REGIONAL REVIEW FINDING

RE: Development of Regional Impact (DRI) Review

<u>Name of Proposal:</u> Microsoft Data Center Palmetto <u>Submitting Local Government</u>: City of Palmetto

MICROSOFT DATA CENTER DRI City of Palmetto Natural Resources Group Review Comments

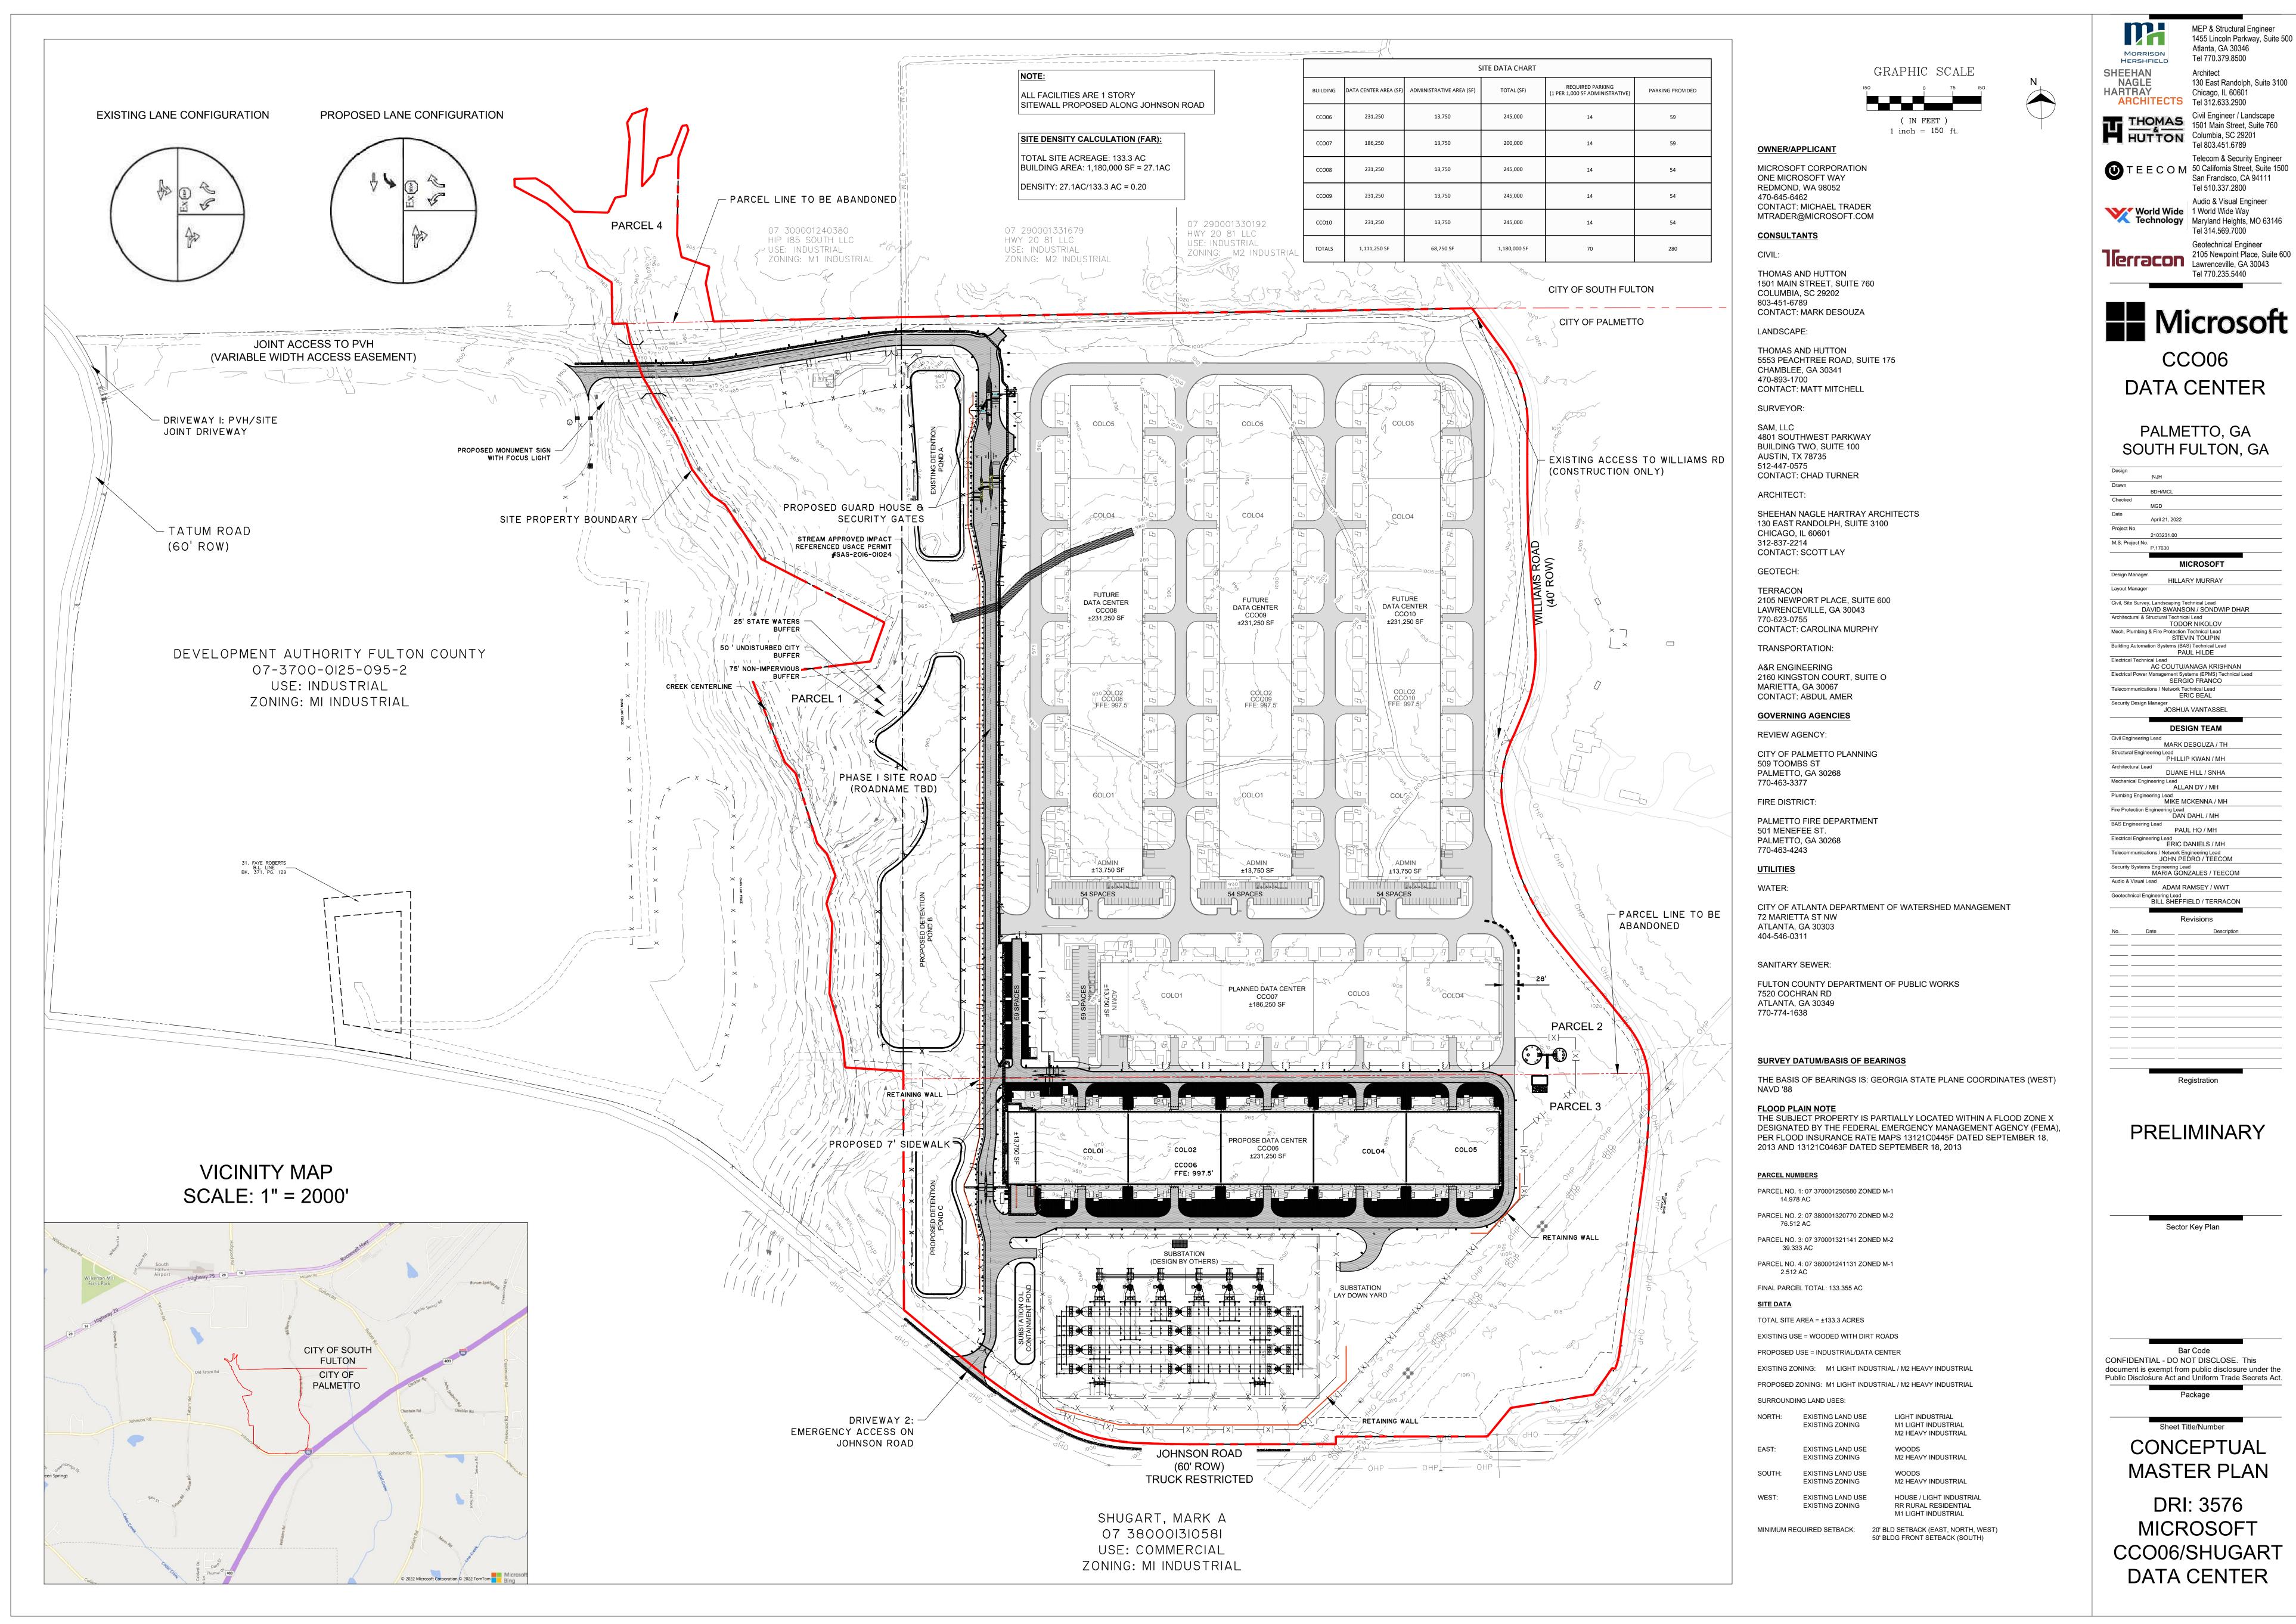
The USGS coverage for the project area shows wetlands near the western edge of the property but no blue-line streams are shown on or near the project property. The submitted site plan shows a stream running north-to south on the western edge of the property, with the centerline of the creek forming the property boundary for a portion of its length. A small branch off that stream into the property is also shown. The 50-foot undisturbed buffer and additional 25-foot impervious surface setback required under City of Palmetto Stream Buffer Ordinance are shown on both streams and are clearly identified, as is the 25-foot State Erosion and Sedimentation Act buffer. The only definite intrusion into the buffers is a proposed road crossing at the northern end of the property. Transportation crossings are exempt from the buffer requirements under the City ordinance. In addition, the western edge of Detention Pond B runs close to the edge of the 75-foot impervious setback along the small branch and a portion of the primary stream. While land disturbance is allowed in the 25 feet beyond the 50-foot undisturbed buffer, mass grading and impervious surfaces are not. Any major grading or impervious surfaces intruding into the setback may require a variance from the City.

Any unmapped streams may also be subject to the City buffer ordinance and any unmapped waters of the state may be subject to the 25-foot State Erosion and Sedimentation Act buffer. Microsoft Data Center DRI
